Issue List

10-16-23 FREDDYS - PROVO, UT

HMIblank
10/17/2023

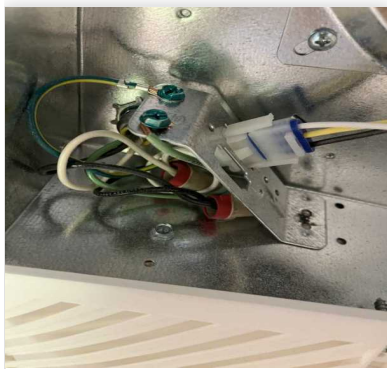
Issue Name : DOAS kitchen HMI blank screen
Description : Kitchen HMI for DOAS unit is blank and cannot be controlled. GC is aware and CAS is scheduled to come look at the DOAS unit to address the fault messages with Morris controls company..
Created By : National TAB **Assigned To :** National TAB - Jacob Davidson
Status : Open
Originated Date : 10/17/2023 - Jacob Davidson - National TAB
